Sloshing or Splashing Noise Caused by Water Inside Doors

Service Category Vehicle Exterior

Section Door/Hatch

YEAR(S)	MODEL(S)	ADDITIONAL INFORMATION
2019 - 2021	Corolla Hatchback	
2020 - 2021	Corolla, Corolla HV

Figure 3.

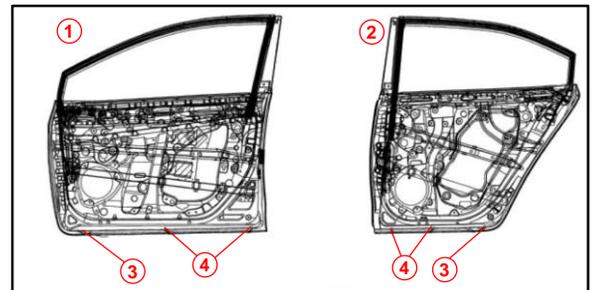
4. Clean the doors and reinstall the eight dust seals.
 - A. Once the water has completely drained from each door, wipe the bottom surface of the doors at each dust seal location to ensure no obstructions are present for installation.
 - B. Reinstall two dust seals per door at the locations indicated.

- The forwardmost dust seal is no longer required for the front doors.
- The rearmost dust seal is no longer required for the rear doors.

5. Discard the four dust seals that are no longer required and confirm the condition no longer exists.
